ACCESSION NBR: 9112170086      DOC. DATE: 91/12/11      NOTARIZED: NO      DOCKET #  
 FACIL: 50-275 Diablo Canyon Nuclear Power Plant, Unit 1, Pacific Ga      05000275  
 50-323 Diablo Canyon Nuclear Power Plant, Unit 2, Pacific Ga      05000323

SUBJECT: Forwards addl info re inservice testing relief requests for check valve testing, consisting of addl justification, per Sept & Oct 1991 telcons. Info covers stroke testing of check valves 8924, 8977 & 8981 after reassembly.

PG&E Letter No. DCL-91-297

Re: Docket No. 50-275, OL-DPR-80  
Docket No. 50-323, OL-DPR-82  
Diablo Canyon Units 1 and 2  
Additional Justification for IST Relief Requests Regarding Check  
Valve Testing

FIGURE 1

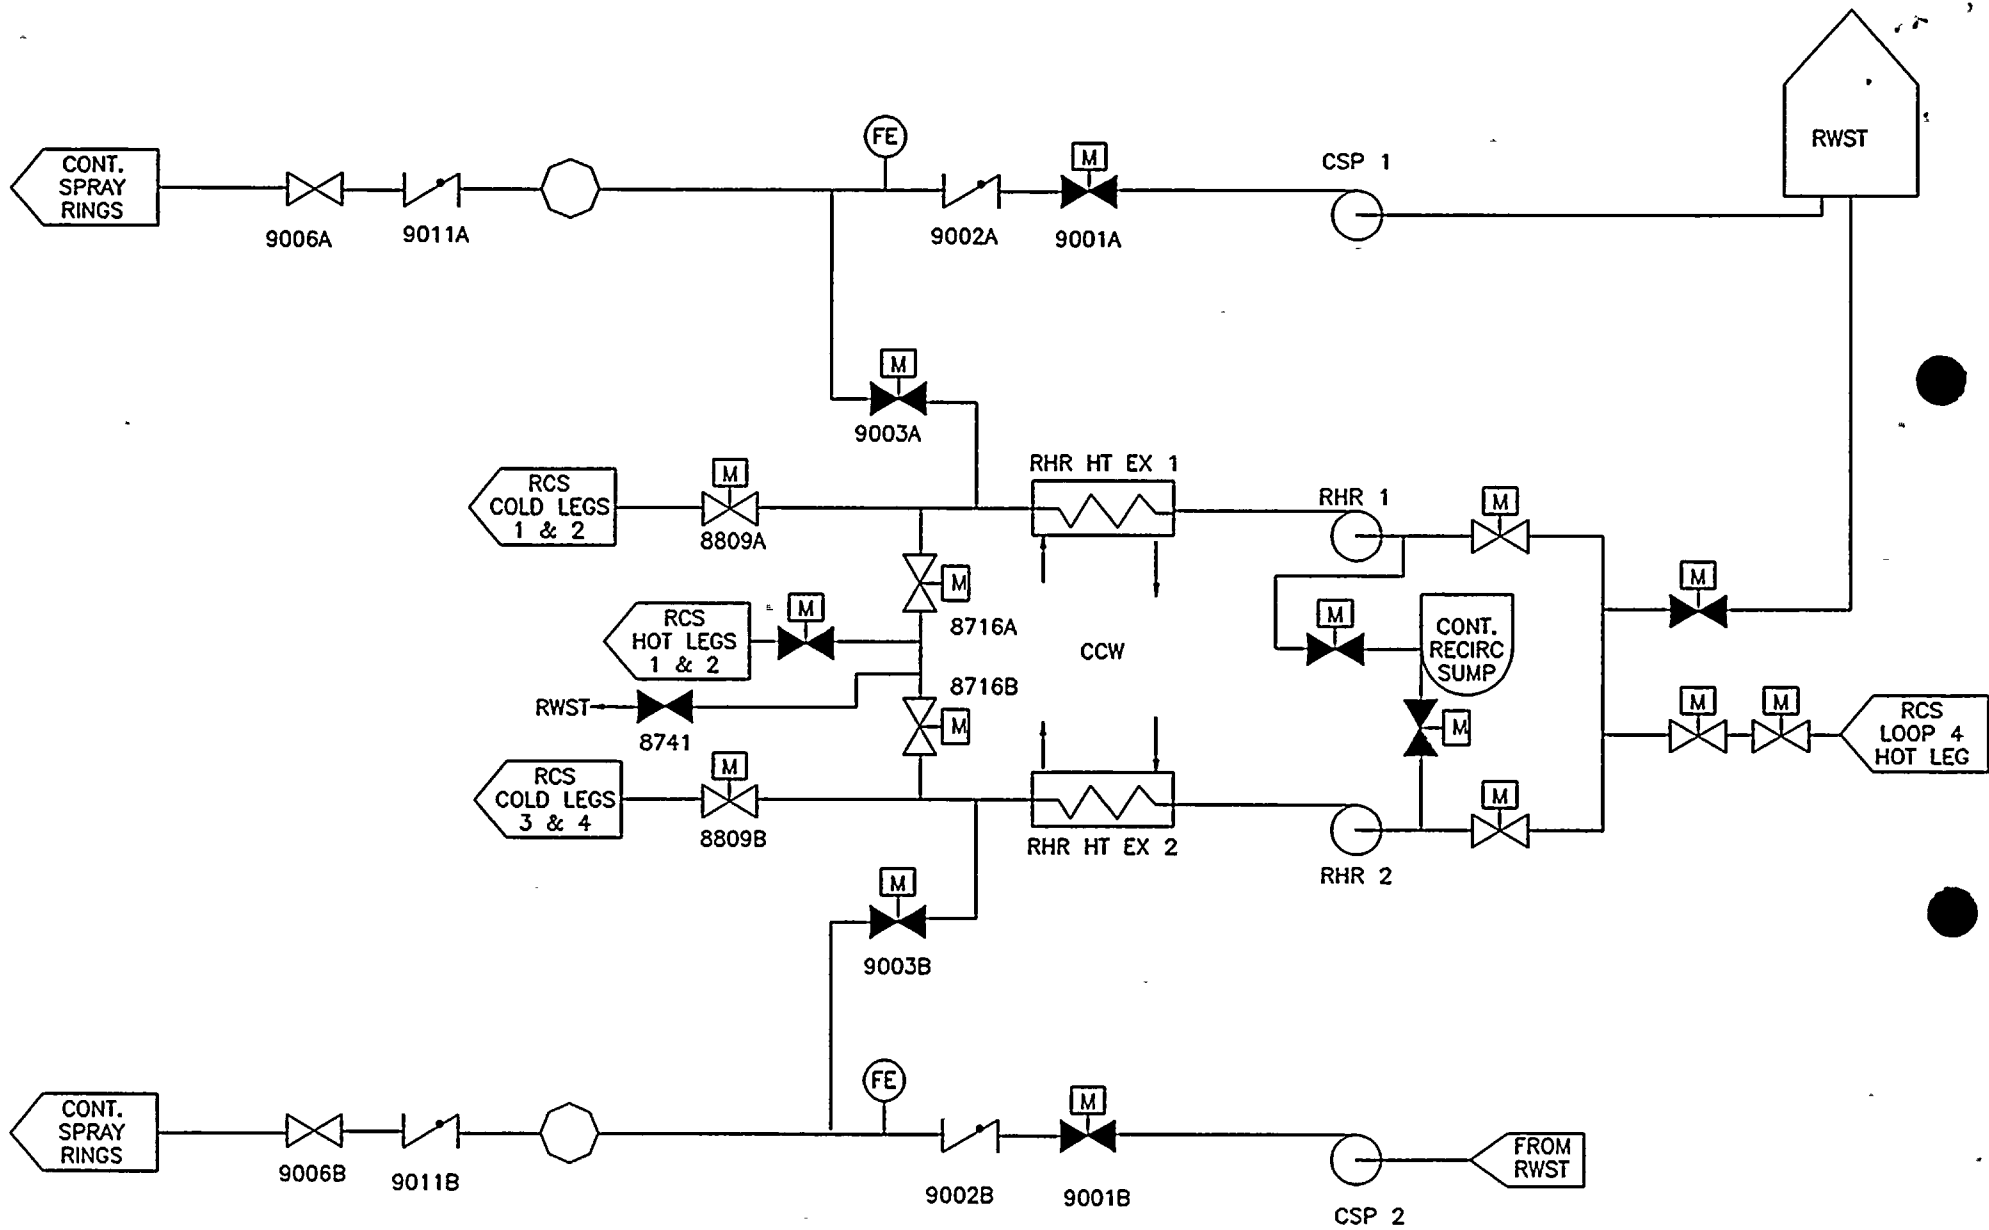
The NRC Staff requested in phone discussions that PG&E provide additional basis to justify not flow testing the valves.

The RHR/CS system valve alignments during normal shutdown are shown in Figure 1. Prior to the Unit 1 fourth refueling outage in March 1991, shutdown testing had been accomplished by implementing the RHR/CS system valve alignment shown in Figure 2. As reflected in Figure 2, in order to partial or full-flow stroke valves 9002A or 9002B during shutdown, the associated CS pump must discharge to the reactor vessel through the RHR system, in accordance with the following instructions:

Because valves 9002A&B are located in essentially dry pipe and are not subject to cycling during plant operation, potential degradation mechanisms are minimal. Therefore, testing valves 9002A&B with flow (either partial or full) results in hardship and unusual difficulties as described above without a compensating increase in the level of quality and safety. Relief request 21 will be formally revised and submitted in the next revision to the IST Program Plan, providing additional justification for not flow testing valves 9002A&B, as described above.

FIGURE 2

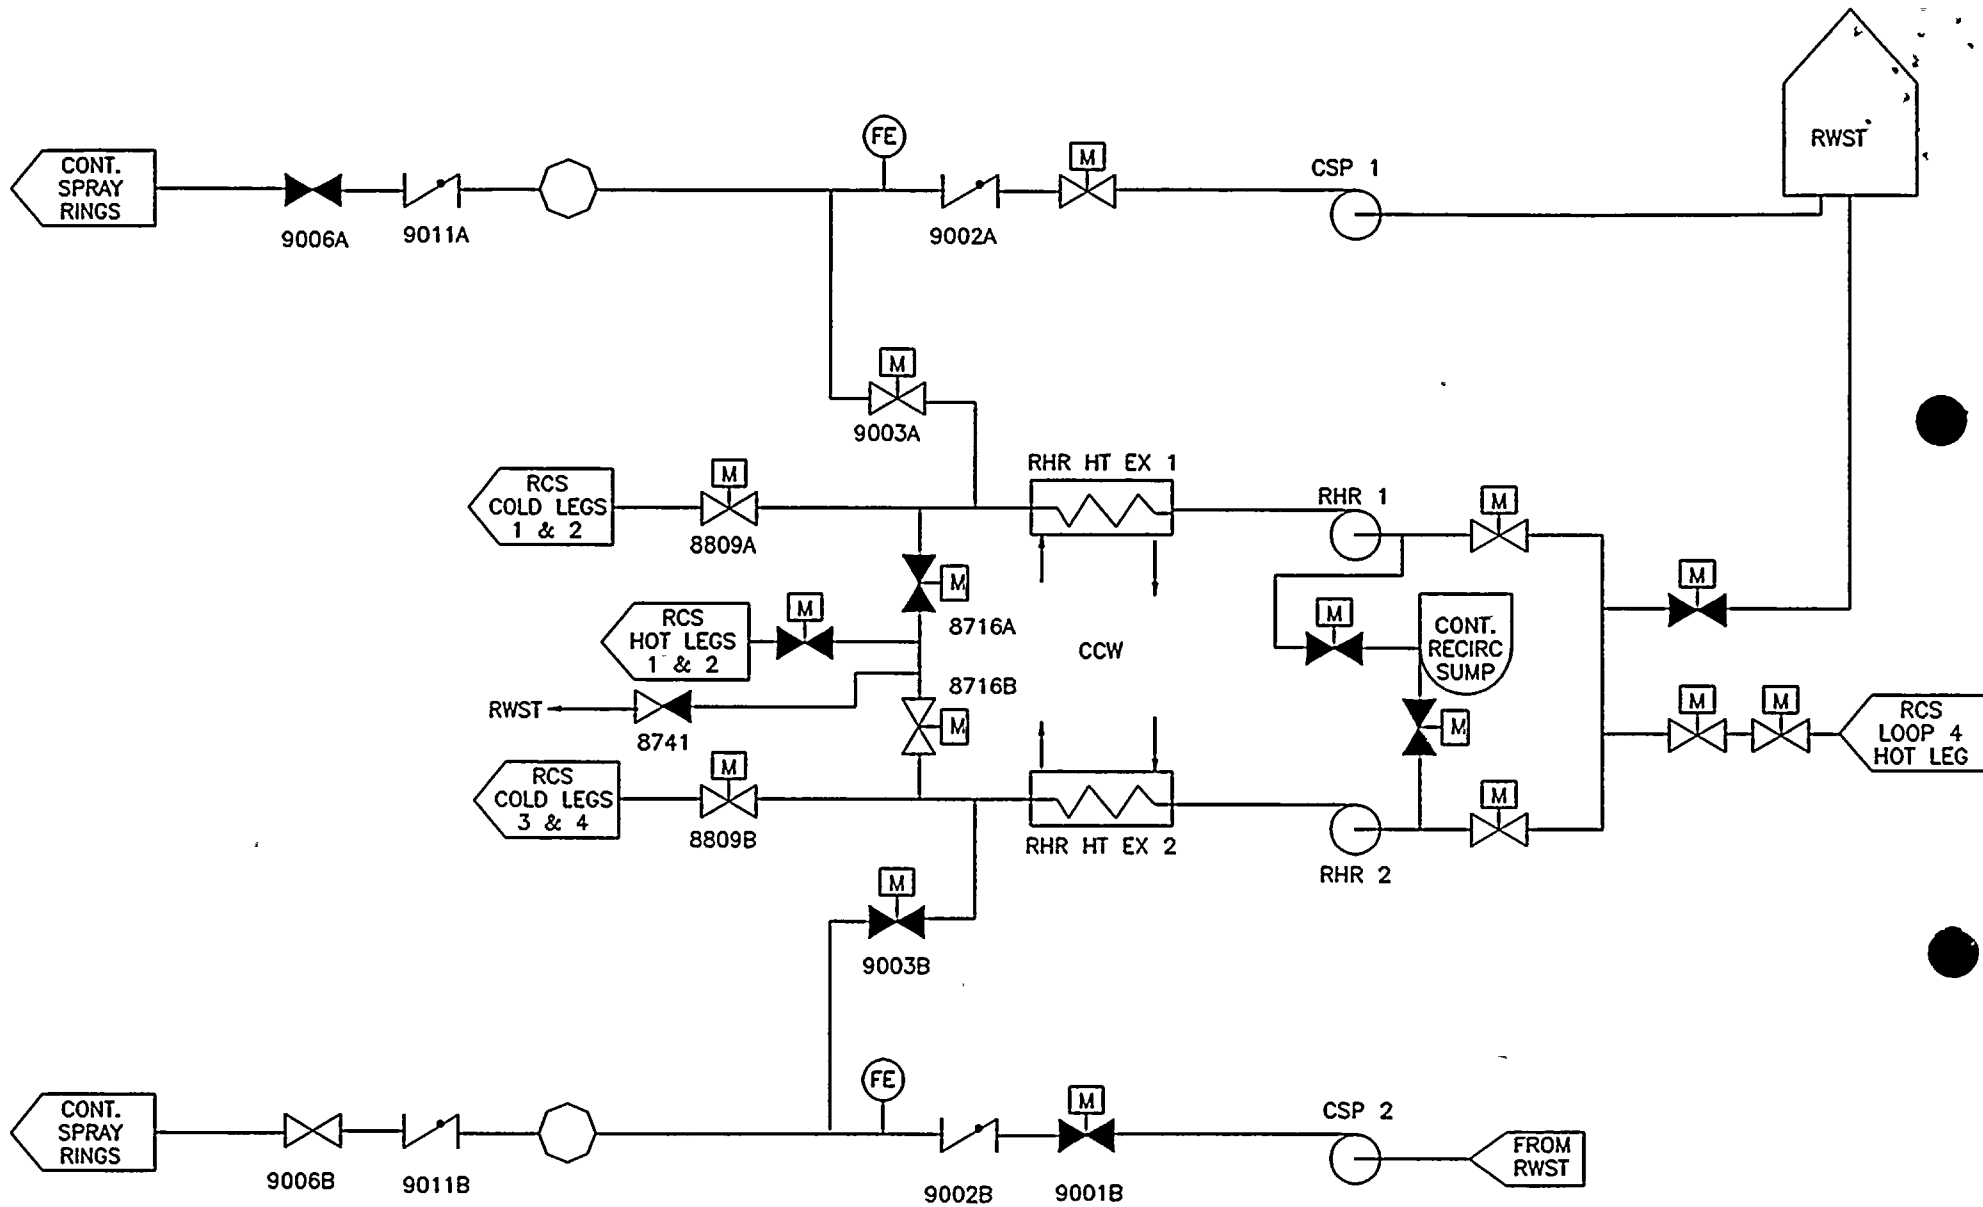
PG&E believes that testing valves 9002A&B in the shutdown configuration shown in Figure 2 places the RHR system in a degraded and precarious operating configuration. This shutdown test configuration is highly undesirable for the plant operating staff because of the operating difficulties and potential consequences described below:

1. If manual isolation valve 9006A or 9006B (from the CS pump to the spray rings) is not fully closed, inadvertent spraying of containment may result that would not be detected until water is emitted from the containment spray nozzles.
2. Because the diversion of water from RHR to the RWST is accomplished by manual manipulations of gate valve 8741 outside of the control room, RCS volume control is extremely difficult and could potentially lead to inadequate RHR flow to the RCS.
3. The problems in controlling RCS volume may lead to an overflowing of the reactor vessel or refueling cavity, spreading radioactive contamination within the containment and potentially damaging plant equipment.

PG&E is currently investigating alternative methods to the Figure 2 testing configuration to allow partial or full-flow stroking of valves 9002A&B during shutdown. If valve stroking by flow is determined to be possible, PG&E will revise appropriate test procedures and submit a revised IST Program Plan.
